UNITED STATES PATENT AND TRADEMARK OFFICE

APPLICATION NO.	FILING DATE	FIRST NAMED INVENTOR	ATTORNEY DOCKET NO.	CONFIRMATION NO.
09/809,074	03/16/2001	Shinya Nagamatsu	204842US-8	5550

Office Action Summary

DETAILED ACTION

FIG.2A

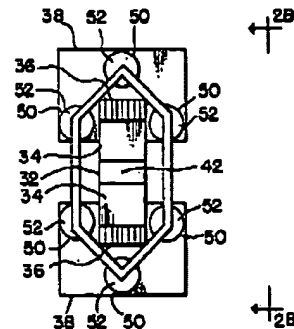
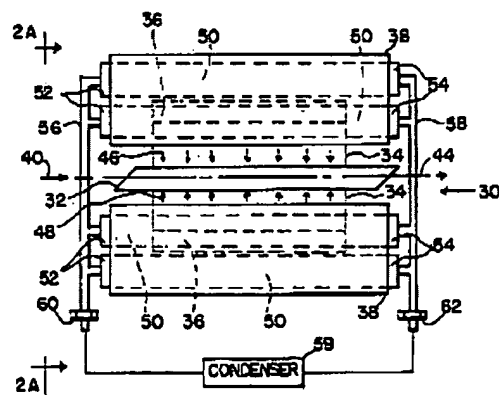
5. Claims 1 and 12 are rejected under 35 U.S.C. 102(b) as being anticipated by Miyake et al (4,791,634). Miyake et al discloses a light source (30) comprising a plurality of densely placed laser diode modules (36) mounted on a mounting portion (38), each of the modules (36) having an output of at least 100 mW (see math below),

and a plurality of heat pipes (50) thermally connected to the mounting portion (38), the plurality of heat pipes (50) having a heat absorbing portion (82) and a heat radiating portion with heat radiating fins (86).

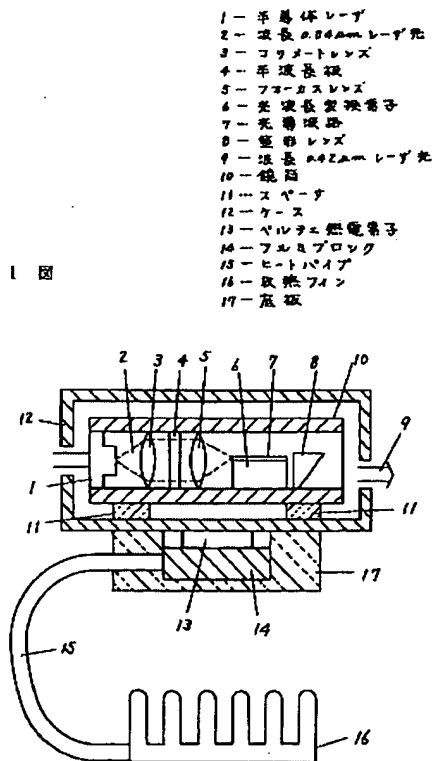
As evidenced in the above excerpts, it is inherent that each laser module produces at least 100 mW of output, because Miyake teaches that:

- (1) the laser modules (36) produce output of about 8 Watts/cm²,
- (2) the laser modules (36) comprise thin diode strips (102) interleaved with heat sink strips (104),
- (3) each thin diode strip has a dimension of 0.5 mm x 5 mm, or equivalently 2.5 mm² or 0.025 cm², and
- (4) each heat sink strip has a dimension of being 0.5 mm x 10 mm, or equivalently 5 mm² or 0.05 cm².

Considering each module to be one thin diode strip and an adjacent heat sink strip, the approximate area per module is therefore about 0.075 cm². Multiplying the

output per area (i.e. 8 Watts/ cm²) and the area per module (i.e. 0.075 cm²) results in 0.600 Watts/module, or equivalently 600mW/module.
